Detroit
Edison

Reference: Enrico Fermi Atomic Power Plant, Unit 2
NRC Docket No. 50-341

Subject: Mark I Containment
Request For Additional Information

Attached please find our response to your July 19, 1982 request for additional information on the Fermi 2 Plant Unique Analysis Report (PUAR). Due to the time constraint, the response is submitted in the question/response format. After you have reviewed and accepted our response, we will incorporate the attachment into the PUAR, revising PUAR pages if applicable.

Figure 10.3-1 - SRV Load Definition

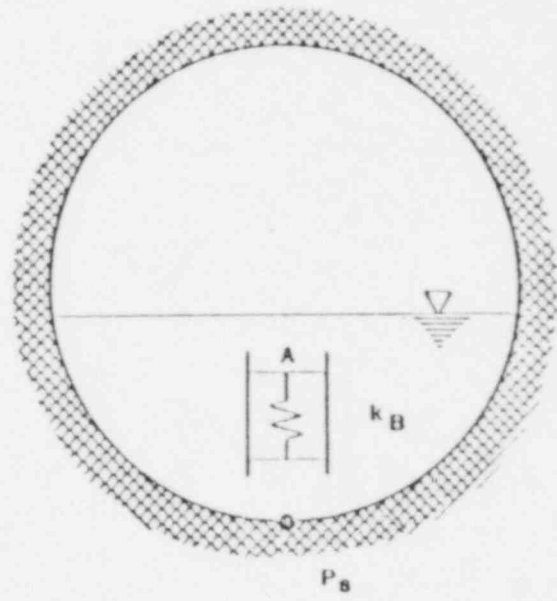
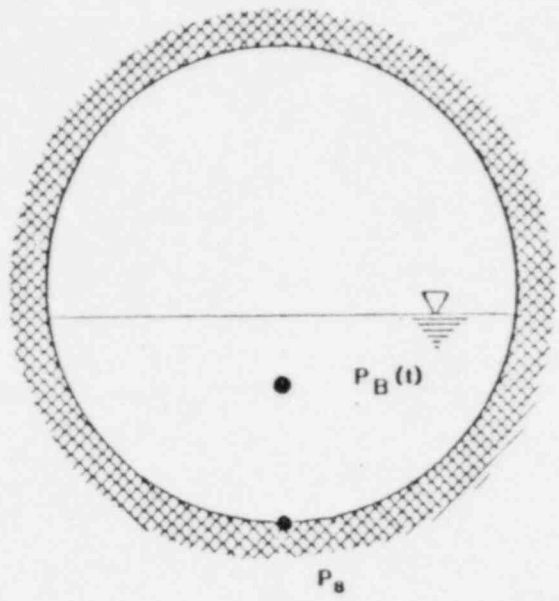
Provide detailed calculations to indicate how the modal correction factors given in Sections 1-4.2.3 and 2-2.4.1 of the PUA report are obtained.

Modal correction factors used in calculating the response due to SRV torus shell loads are obtained by dividing the response of an initial value or free vibration problem by that of a transient forced vibration response problem. The physical representations for the analogs used in developing these correction factors are shown in Figure 10.3-1. Two representations of source pressure in a rigid tank are shown. The transient response problem consists of a rigid torus with a pressure source, P_B , which is prescribed as a decaying cosine function. The initial value problem consists of a similar torus which contains a spring and disk mechanism for providing an impulse to the surrounding pool water.

The forced vibration analog is subjected to an applied loading, described as

$$P_B(t) = P_B e^{-\lambda t} \cos \omega_B t$$

The initial conditions for the free vibration analog are prescribed by compressing the spring, k_B , a distance, Δl , such that at time equal to zero the force in the spring is equal to P_B . Therefore, at time equal to zero, both the forced vibration and free vibration analog have the same applied load magnitude.
